M.A.C.K Shirts Ltd (9649)

Basic Apparels Ltd (9791)

Plot #135-138, Abdullahpur, Uttara
(+23.880716N, +90.401497E)

Identified Priority 2 Concerns

Multiple water tanks on the roof

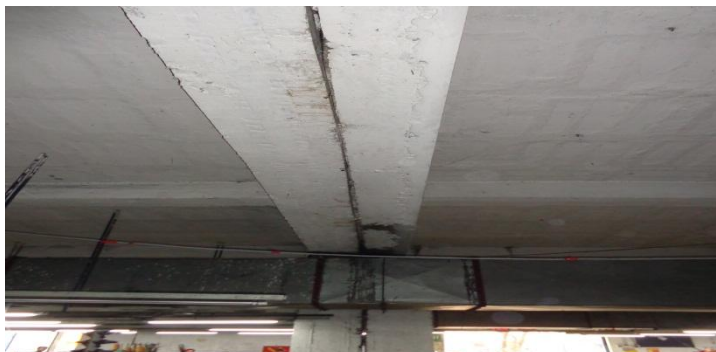
Capacity of the roof slab with regards to the quantity of water tanks in small area. These should be spread out ensure that the load is not carried out by same structural elements

Capacity of the roof slab and columns under the water tanks

- Verify the capacity of the slabs, beams and columns beneath the water tanks.

- This item can be managed by the loading plan mentioned in the item 1.
